From: Katherine Williams
Sent: 11 August 2025 17:32
To: Debbie Marriage
Cc: [REDACTED]
Subject: FW: DM/25/0096 - Unit 19, Bolney Grange Business Park, Bolney
Attachments: 13413_1105=P2_Section through proposed extension over existing ditch.pdf; 13413_1101P2_Drainage Strategy.pdf; Re: DM/25/0096 - Unit 19, Bolney Grange Business Park, Bolney

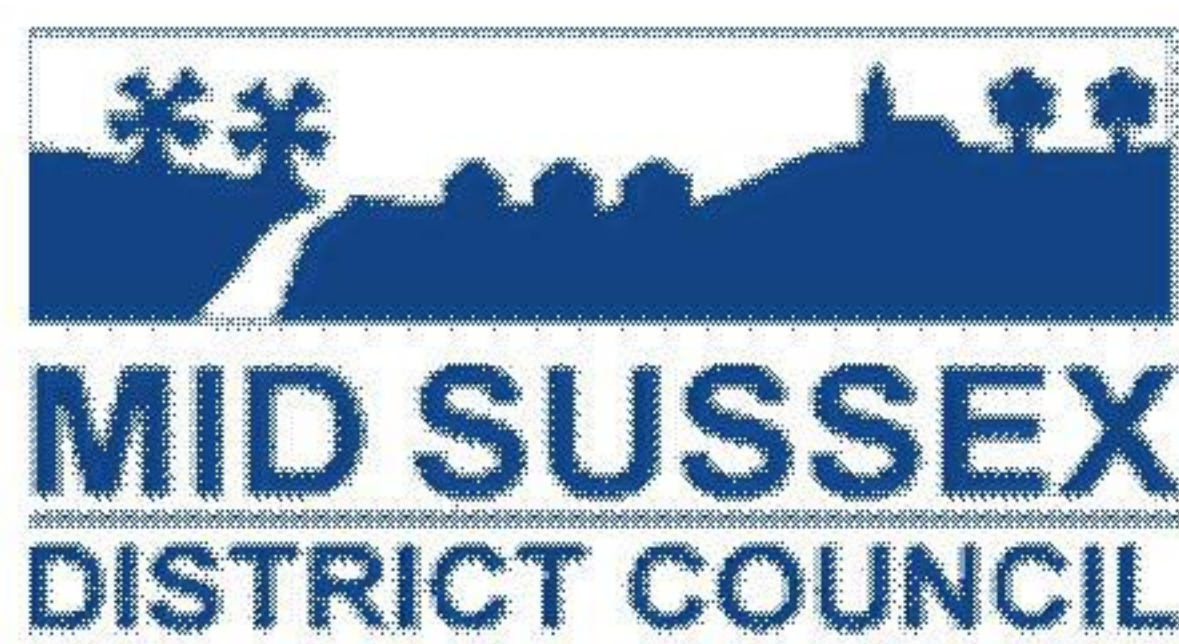
A maintenance strip along the watercourse requires that no new development, including foundations and no construction activities, are within 5 metres of the watercourse. Therefore, the proposed maintenance hatches would not overcome the objection raised as the required maintenance strip would not be maintained.

I appreciate the frustrations in the delay in the comments from the Flood Risk and Drainage Team over the course of the application and the recommendation of the application, however given the concerns raised and the form and position of the extension this objection cannot be overcome.

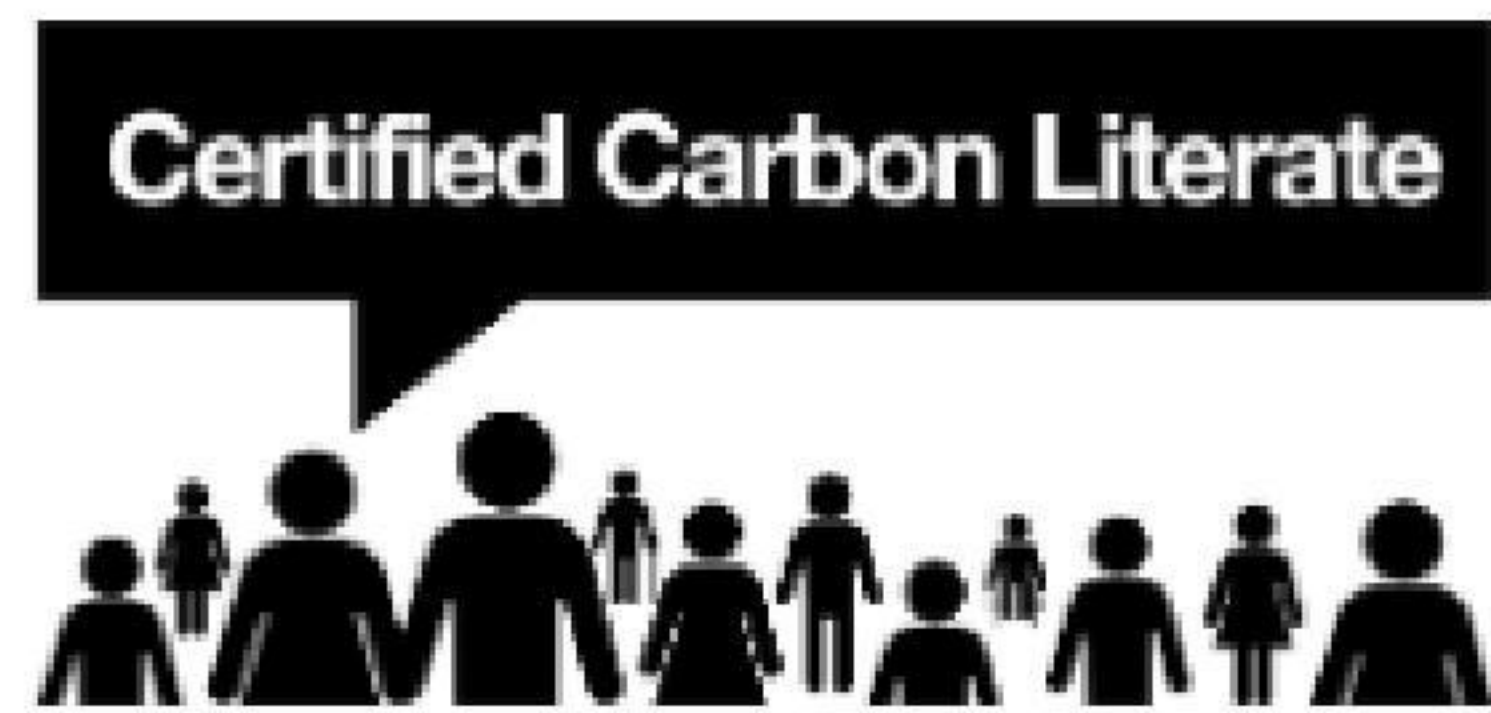
The Council's Flood Risk and Drainage Team have taken advice from County Council, who are the Lead Local Flood Authority, on this matter. They have confirmed that the ditch is a watercourse, and therefore there is a duty to keep it clear of silt, debris and in good working order, which would no longer be possible should the proposed extension be constructed, and therefore contrary to WSCC policy.

The Flood Risk and Drainage Team therefore object to the application on the same grounds as their original comments.

If this is the reason given, then we can easily allay the LLFA's concerns. Hatches can be placed in the floor of the extension, as shown on the attached plans, allowing access to the ditch below. The hatches have been added to the drainage strategy report.

The extension will be on screw piles (the client is a screw pile supplier) and will oversail the ditch with one metre of head room. This allows for someone to crawl under the floor of the extension if needed, to remove any blockages. In any event, the hatches will mean that crawling is unlikely to be necessary.

The ditch can be easily kept clear of silt, debris and in good working order. Martin Roberts, Director at GTA Civils, assures us that this is a common arrangement and would be more than sufficient to keep the ditch in good working order. Please can you pass these revisions to the LLFA, as I anticipate this will be sufficient to address their concerns.
